**ADDENDUM NO. 19**

**April 22, 2021**

**STUDENT HEALTH AND COUNSELING CENTER  
PROJECT NO. 950578**

### UCR Bike Lanes

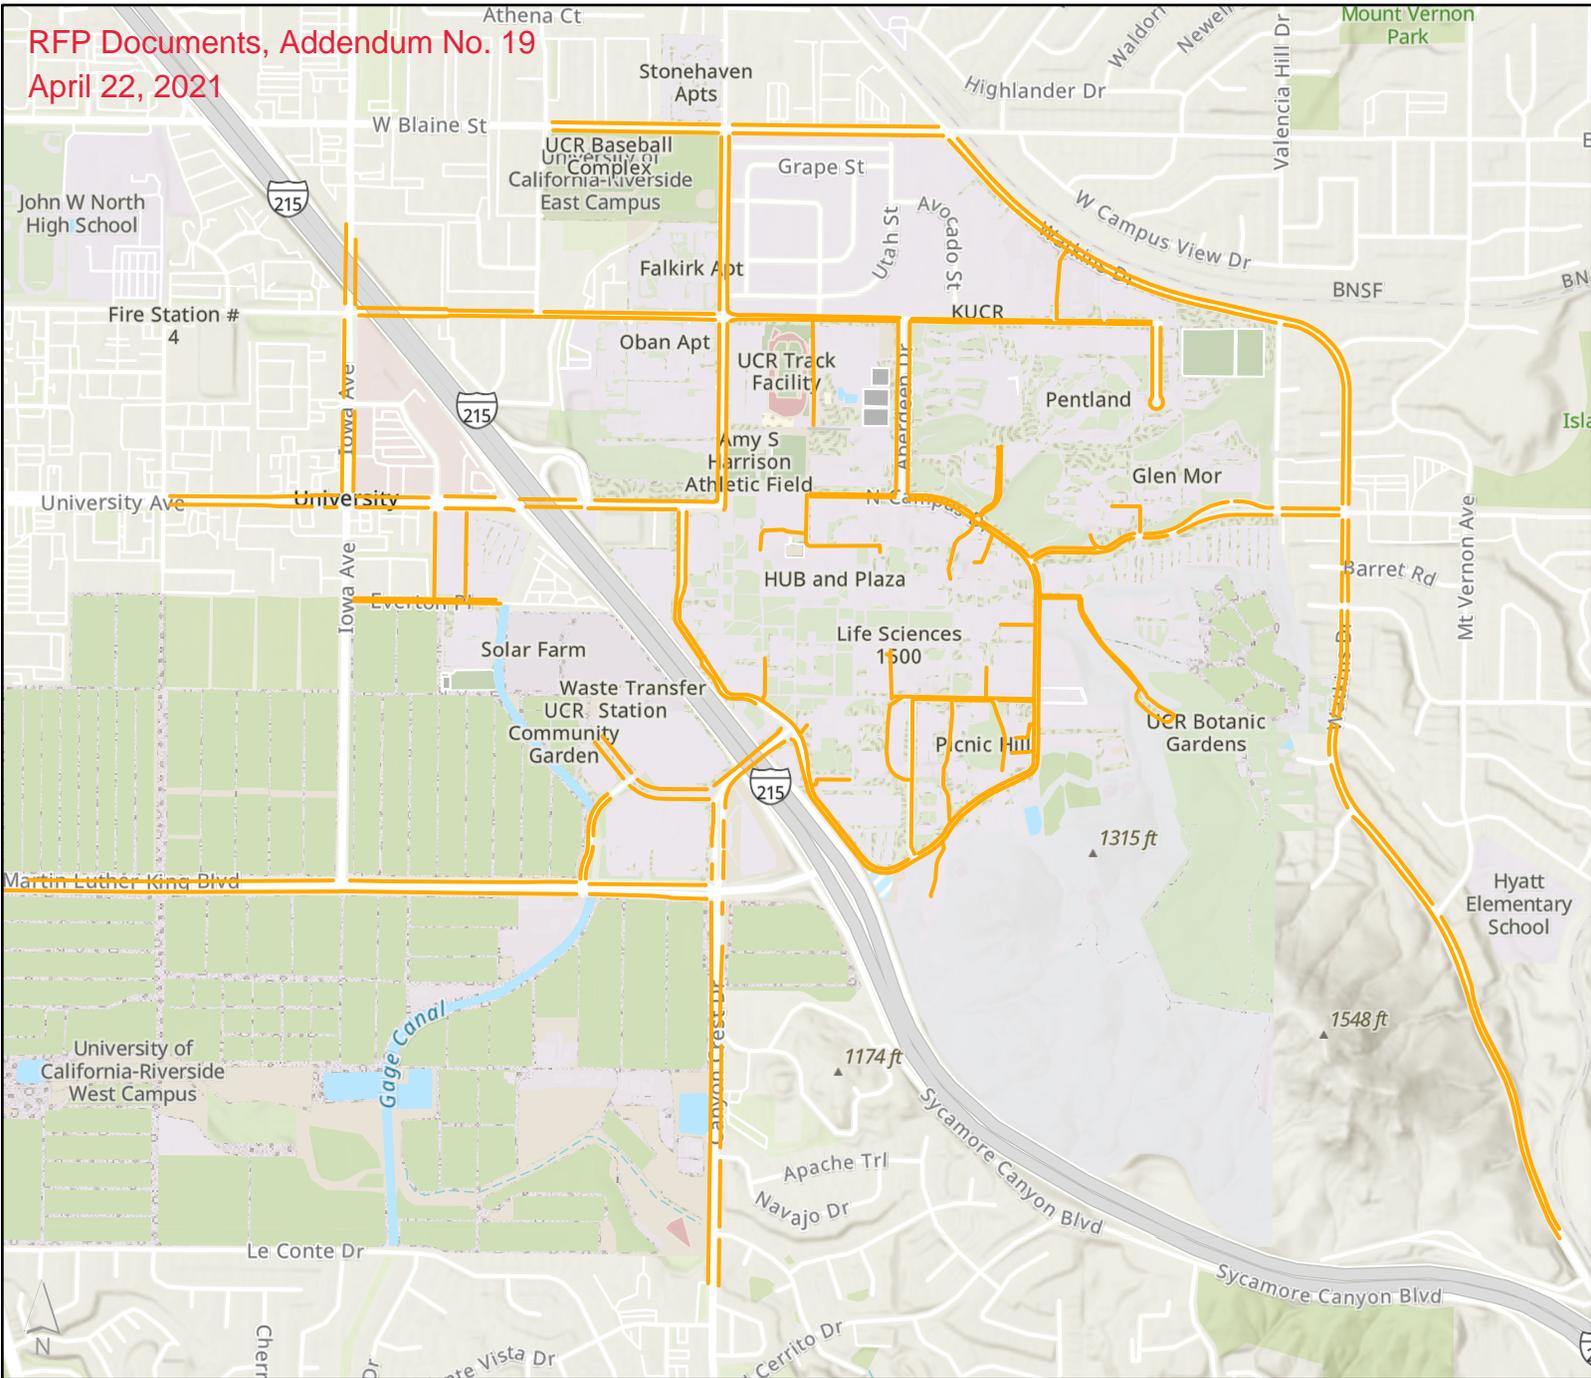
Bike paths for North District, Dundee Glasgow, & The Barn areas need to be updated 4-19-21
